FAIRFAX COUNTY

STAFF REPORT

**APPLICATION RZ/FDP 2001-MV-025
(In Association with RZ 2001-MV-026)**

LAUREL HILL SOUTH

ENTRANCE LANDSCAPE DETAIL
 & NOISE WALL DETAILS
 PULTE HOMES \ LAUREL HILL

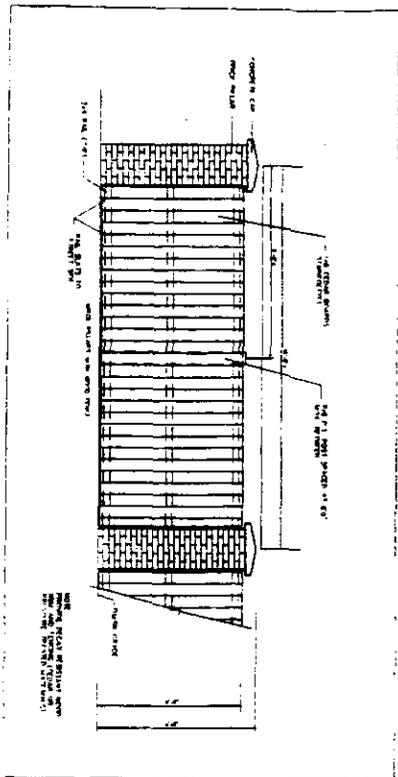
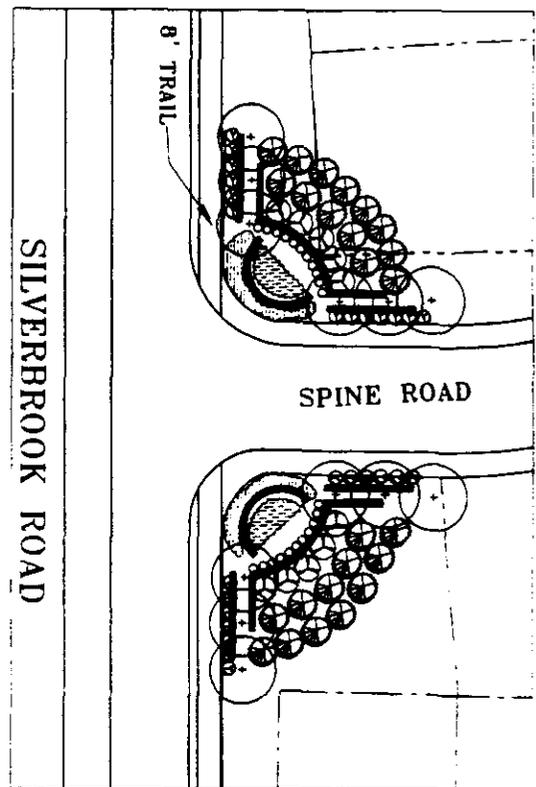
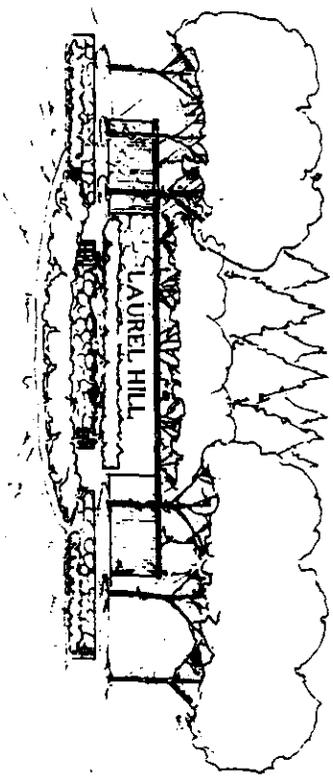
The CDP/FDP includes an illustrative sign on Sheet 13. Since no dimensions or other characteristics are provided, it cannot be determined that the sign meets the area limitations. However, it would appear that the sign may exceed those limits, especially where the sign will flank a major entrance.

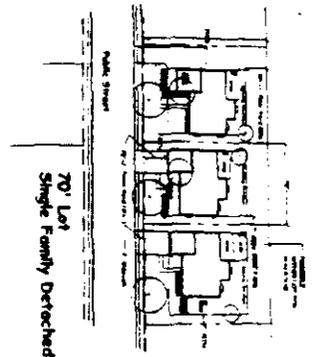
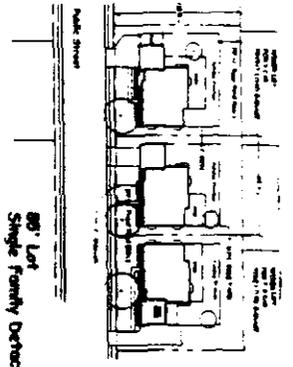
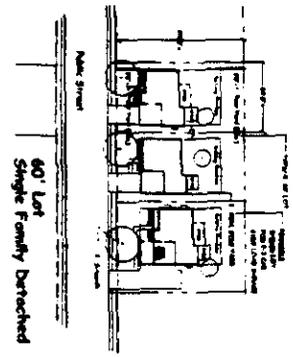
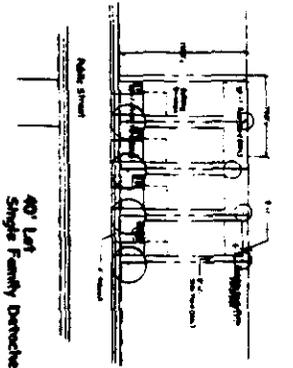
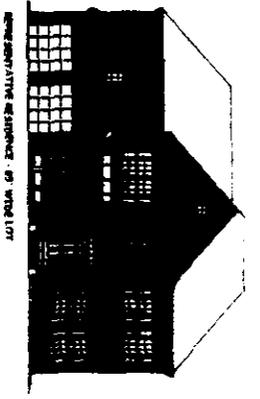
Sheet 14 includes a depiction of a typical entrance sign for the community. However, dimensions have not been provided. The CDP/FDP places this sign at each entrance from Silverbrook Road, on the access road to the south, at the entrance to each land by from the loop road.

The limits of clearing and grading have not been revised to include additional tree preservation areas at the rear of the lots. The typical yards shown on Sheet 14 are limited to a twenty (20) foot deep rear yard of the revised CDP/FDP, which does not provide a great opportunity for tree preservation on the lots. The proffers and the CDP/FDP include commitments to preserve trees around the area that was disturbed as part of the remediation activities on the property and the recommended commitments have been included in the draft proffers, including the tree protection fence. The buffering and screening recommended in the plan for the transportation center is not required because the transportation center is to be demolished and removed. While the applicant has not provided a landscaping scheme for the areas around the SWM/BMPs, the proffers state that those areas will be landscaped to the maximum extent possible per the County's policy regarding such landscaping. This commitment will result in substantial reforestation in the area disturbed by the previous remediation activities. Because a large portion of this area will be devoted to the SWM/BMP in Land Bay E; the proposed FDP development conditions require the submittal of a reforestation plan for the area not addressed by the pond plantings. The CDP/FDP has not been revised to provide a more detailed plant schedule at this time. The CDP/FDP does include landscaping that provides for the types of material to be planted rather than specific species; however, the proffers include a commitment to endeavor to use native species. Additional detail can be provided as part of the approval of the site plans/subdivision plats.

FIGURE 15

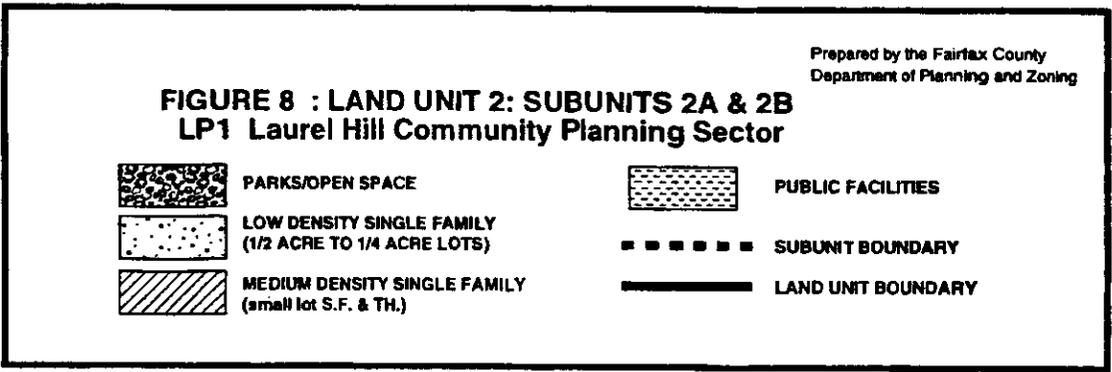
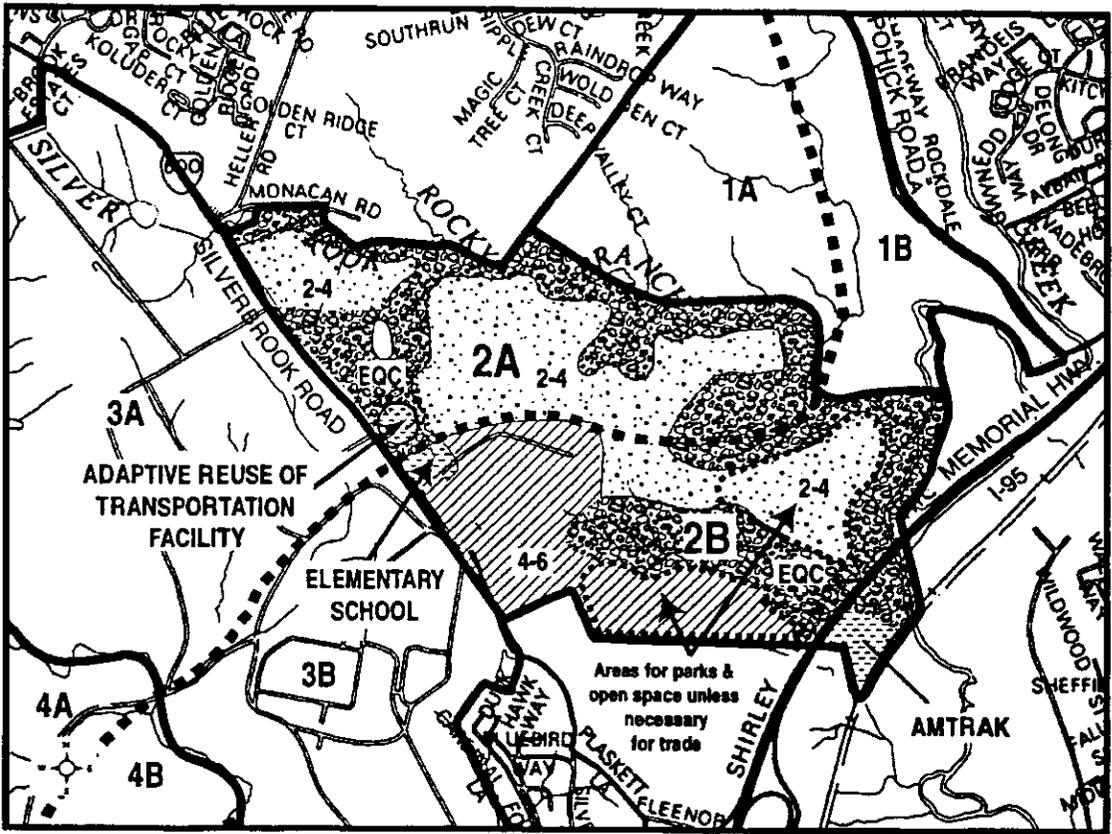
The application raises concerns relating to how the development proposal has complied with Plan guidance for density. There are two density ranges specified for the majority of the developable land within the sub-units; 2-4 du/ac in Sub-unit 2A, and 2-4 du/ac and 4-6 du/ac in Sub-unit 2B. Other portions of developable land are planned for public facilities and parks. The proposed CDP/FDP is organized by land bays that correspond to the density ranges shown on the Plan map and not to the sub-unit boundary line shown on the Plan map. The tables in the Plan are also organized by density ranges. Therefore, the following density analysis also relates to the planned density ranges as shown on the Plan tables and map.

* The Plan specifically indicates that the total number of townhome units should not exceed 20% of the number units provided in Sub-unit 2B, not 20% of the units planned for 4-6 du/ac. Therefore, the total number of units listed above includes 100 units contained in that portion of Land Unit D within Sub-unit 2B as shown on Figure 15.

Based on the specific Plan recommendation that total number of townhouse units should not exceed 20% of the total number of units provided in Sub-unit B, staff concludes that only the applicant's alternative development scenario, as presented on Sheets 9, 10 and 11 of the development plan, conforms to the Plan. However, should the Plan text be further modified to allow additional townhome units, all development elements of both development proposals would be in conformance with the Plan.
